I-90 Allston Multimodal Project ***Boston, MA***

National Environmental Policy Act Review
Scoping Summary Report

August 7, 2020

**No Build Alternative
Figure 2**

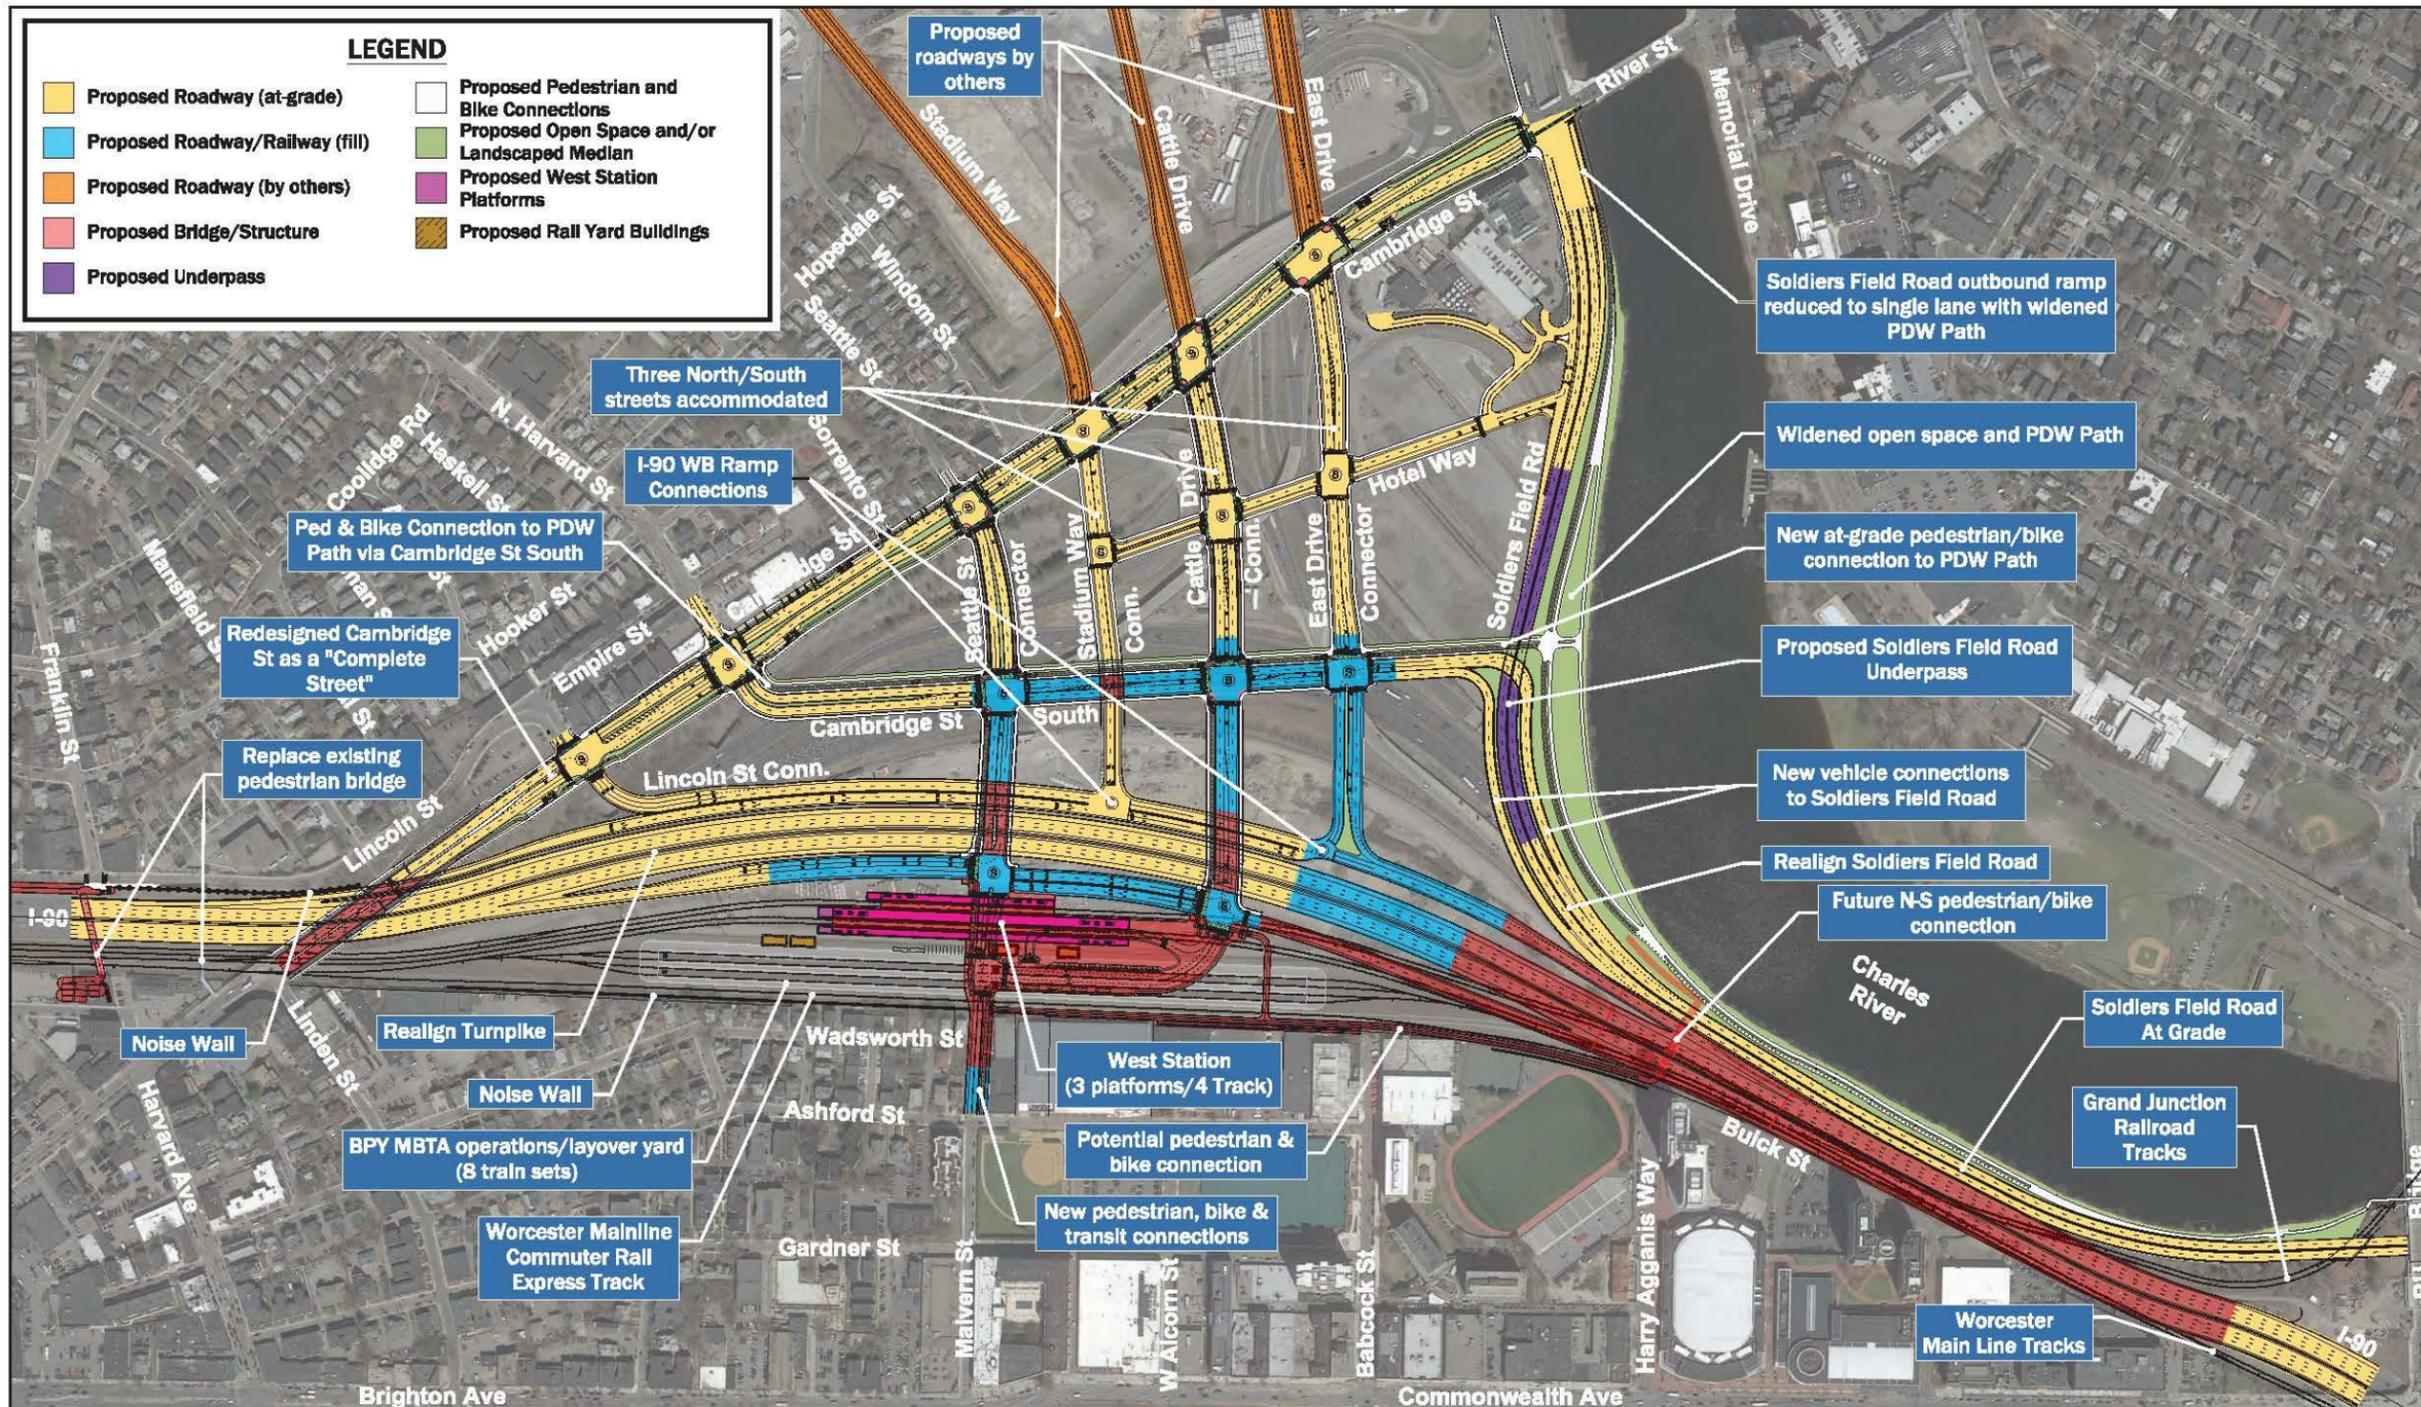
1804	SKai1	4	11/7/2019	No Build	The No-Build is obvious to general reader, but unfortunately as an alternative it is not represented by plan drawings, sections or profiles. If the EIS is to be a comparison with the No Build, that option must be presented in a clear and relatively complete manner.	See Figure 2 of the Scoping Summary Report.
1805	SKai1	5	11/7/2019	No Build	Variations on the No-Build would include the alternative of rehabilitating the existing viaduct in the throat area or a total reconstruction as a duplication of the existing structure. For clarity I prefer to call this the "Callahan Option" because that is what was built by Bill Callahan in the early 1960s when he was forced not to build on river parkland. The Scoping Report properly does not recommend the Callahan Option to be included as an alternative in the EIS.	The No Build will be carried forward to the Draft Environmental Impact Statement for further analysis. In addition, a Modified Highway Viaduct in the Throat Area under the 3L Re-alignment Alternative will also be carried forward into the Draft Environmental Impact Statement for further analysis. See Section 5.4 for further discussion.

The No Build alternative has been updated since publication of the Scoping Report to include major preservation of the existing I-90 viaduct because MassDOT must and will fix the aging I-90 viaduct should the multimodal Project not be implemented. The scope of work would also include replacement and repair of various superstructure and substructure elements of the Cambridge Street Bridge over I-90 and MBTA Railroad. Preservation of the Franklin Street Pedestrian Bridge over I-90 and MBTA Railroad would include joint repairs and column patching (See Figure 2). This preservation and rehabilitation could be undertaken by MassDOT by right as a maintenance activity for this section of I-90. This alternative would not change access or egress points to I-90. The No Build alternative would not realign the highway, would not realign SFR, would not reconfigure the interchange, would not provide any upgrades to the PDW Path, and would not include a future West Station.

The updated No-Build (Major Preservation) Alternative (Section 5.2.1) does not fully meet the purpose and need of the Project. However, the alternatives analysis is the heart of any environmental impact statement and should provide a thorough comparison of the environmental impacts associated with all reasonable build and no build/no action alternatives (40 CFR §1502.14(d)). Therefore, the updated No Build Alternative will be carried forward into the DEIS for further analysis (see Figure 2).

**3L Re-Alignment Alternative
Modified At-Grade Throat Area Option Plan
Figure 9**

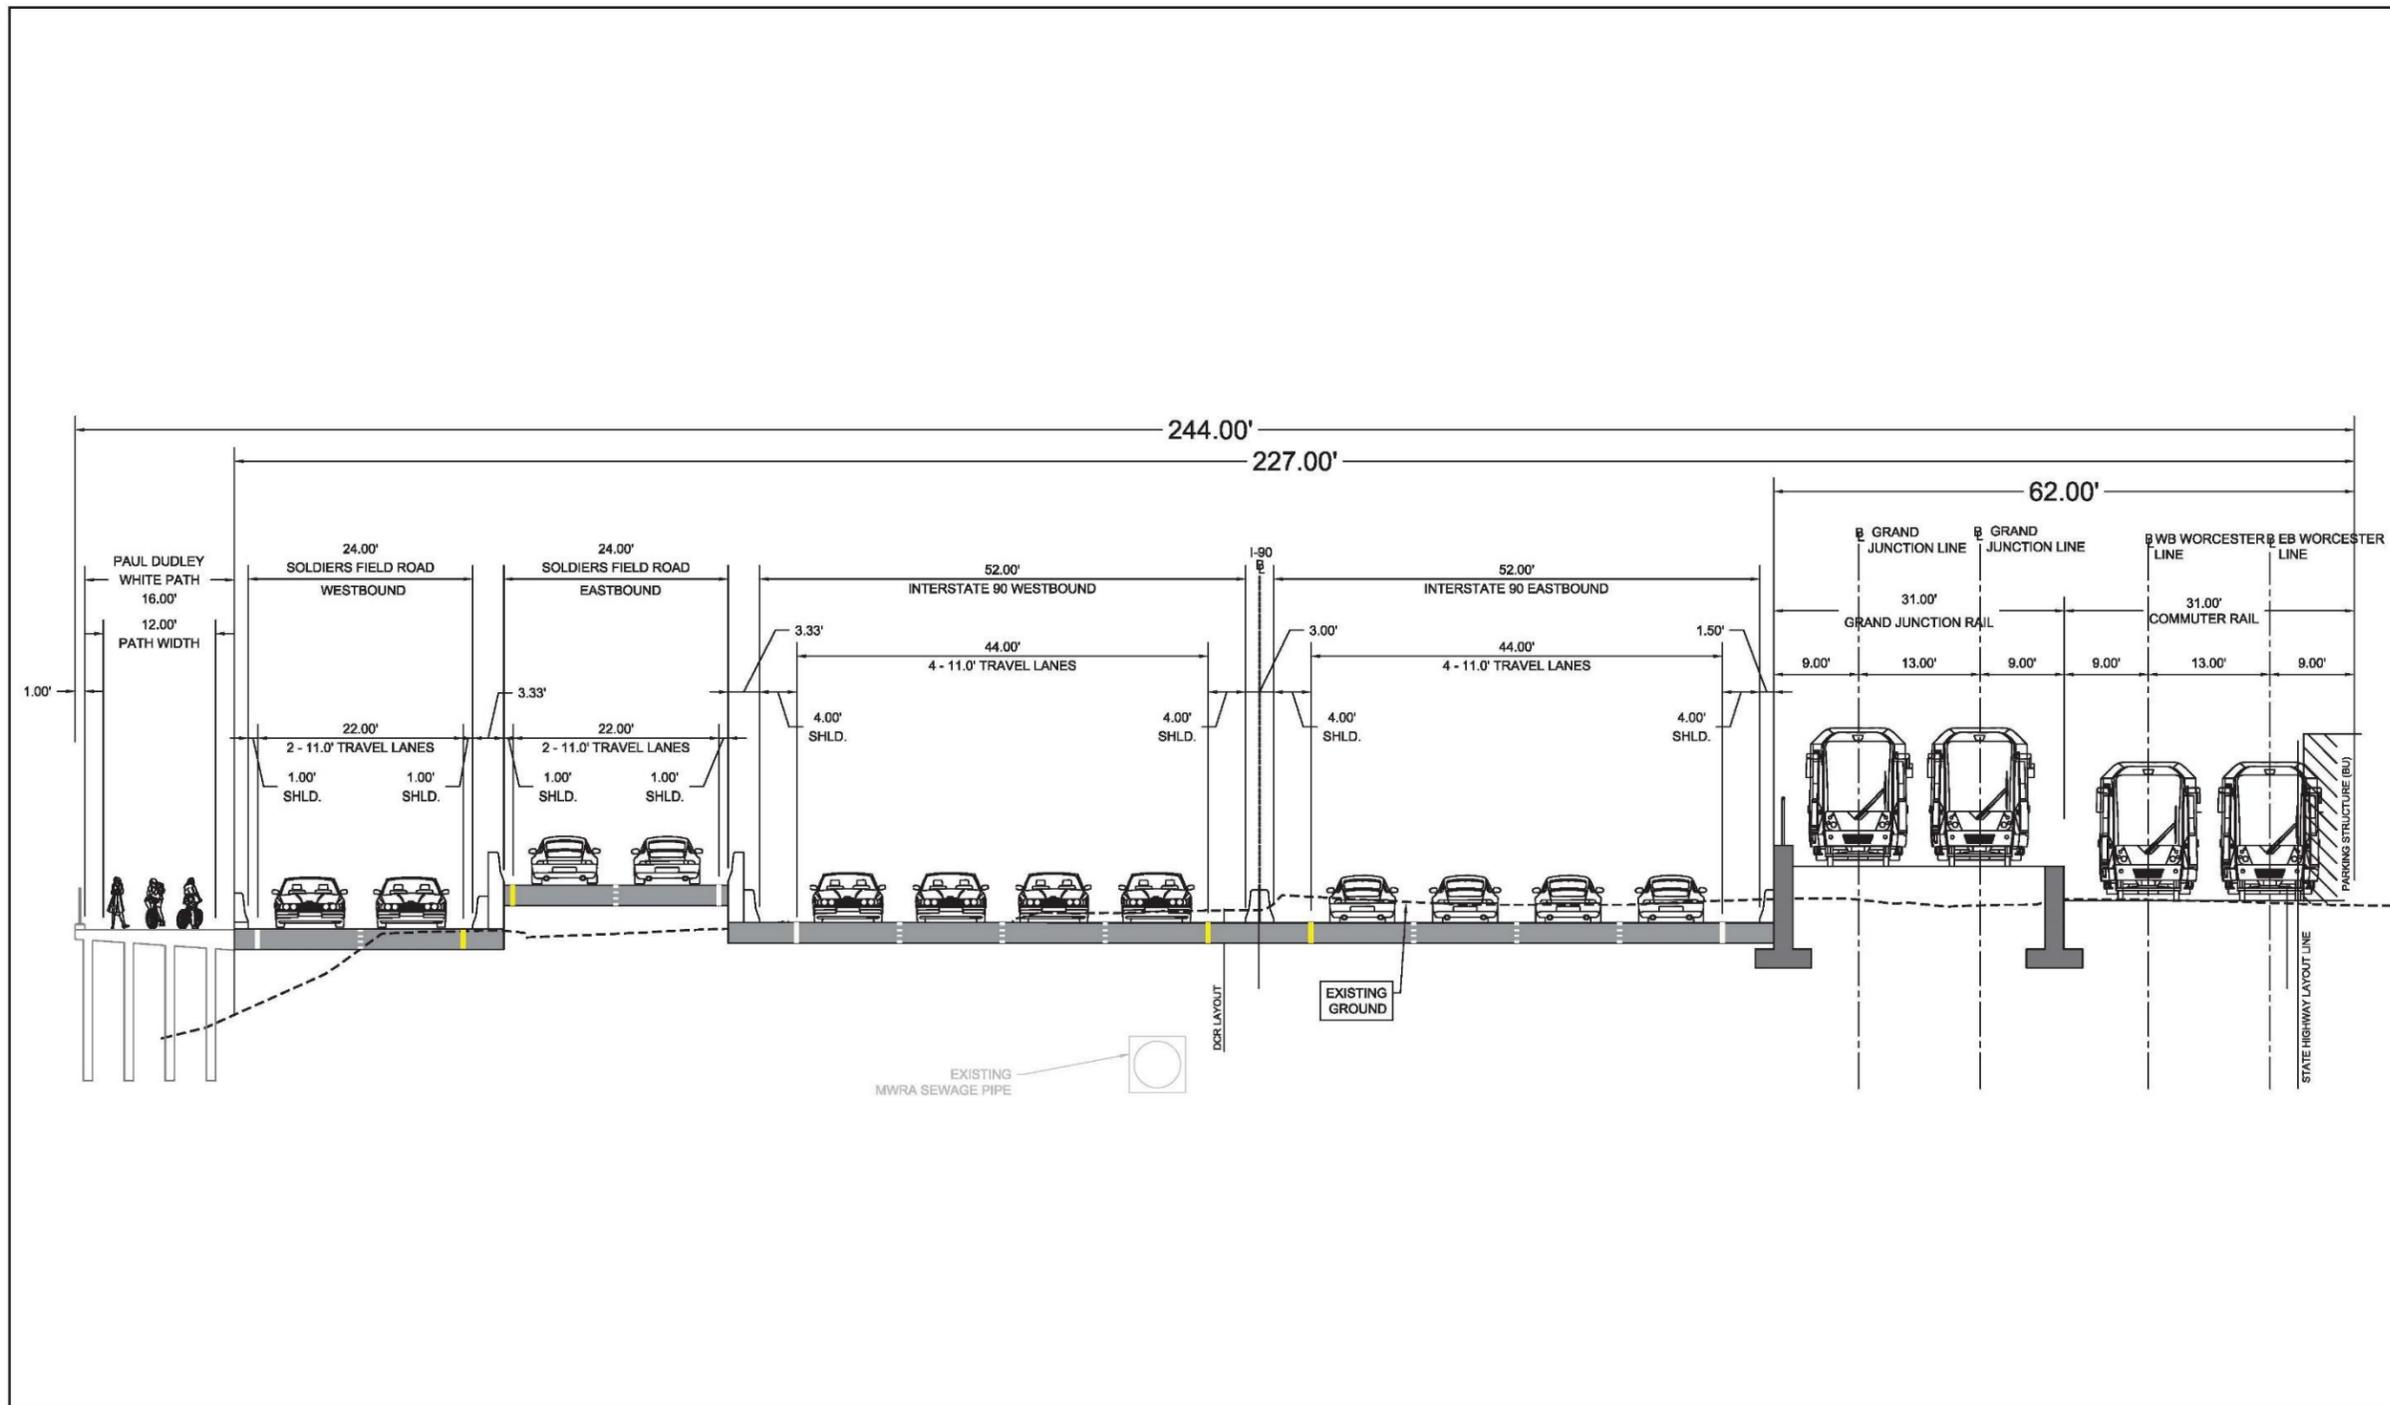
Response: As indicated in Section 3.3.3 of the Scoping Report, the At-Grade Throat Area Option was suggested for dismissal from further evaluation because it did not fully meet the purpose and need. However, public comments received on the Scoping Report suggested an at-grade option could provide other benefits, such as cost and schedule benefits, to the Project. Therefore, the Modified At-Grade will

In addition, the design of the Modified At-Grade Throat Area Option also addresses potential operation and safety issues associated with the all at-grade design. The at-grade design described in the Scoping Report included narrow I-90 shoulders and SFR travel lanes to minimize permanent impacts to the Charles River, but this configuration would also degrade the operations of the roadway, especially for maintenance activities, leading to unacceptable impacts for users of I-90 and posing safety concerns. In particular, these narrow shoulders would not provide adequate space for stormwater or snow collection and conveyance, posing hazards to users. Therefore, similar to the SFR Hybrid and Modified Highway Viaduct designs, the Modified At-Grade design includes four-foot wide left and right shoulders on I-90 (eight additional feet total), which are wider than the designs presented in the Scoping Report. A minimum of four-foot shoulders, adjacent to the I-90 travel lanes on either side, are necessary for the safe and effective operation of the highway, including stormwater collection and conveyance to prevent flooding and ponding on the road surface and clearing snow in order to keep I-90 open during storms. SFR travel lanes have also been increased from 10-feet to 11-feet to match existing lane widths of the SFR Hybrid and Modified HV. See Section 5.2.3 for further discussion of the SFR Hybrid and Modified HV Throat Area Options. These shoulder and lane designs include the minimum acceptable widths to MassDOT. Accordingly, the Modified At-Grade Option is a safer and operationally optimized version of the at-grade designs proposed.

Several commenters indicated an at-grade design could meet the purpose and need of the Project if design refinements were made to this option. MassDOT has further refined the design of a Modified At-Grade Throat Area Option (See Figures 9-10) to allow for a future bicycle and pedestrian connection from neighborhoods in Allston, Brighton, Brookline and Boston University to the Charles River Reservation, thereby meeting the purpose and need of the Project. In addition, the design of the all at-grade Throat Area has been refined to address potential operation and safety issues associated with the all at-grade

be carried forward into the DEIS for further analysis. Multiple design refinements have been proposed to provide an at-grade Throat Area option that meets the purpose and need. This updated design, re-named the Modified At-Grade Throat Area Option, will result in permanent encroachment into the Charles River.

this option including cost and schedule benefits as well as potential design modifications to further minimize environmental impacts. Therefore, the Modified At-Grade will be carried forward into the DEIS for a comprehensive comparison of Throat Area options.
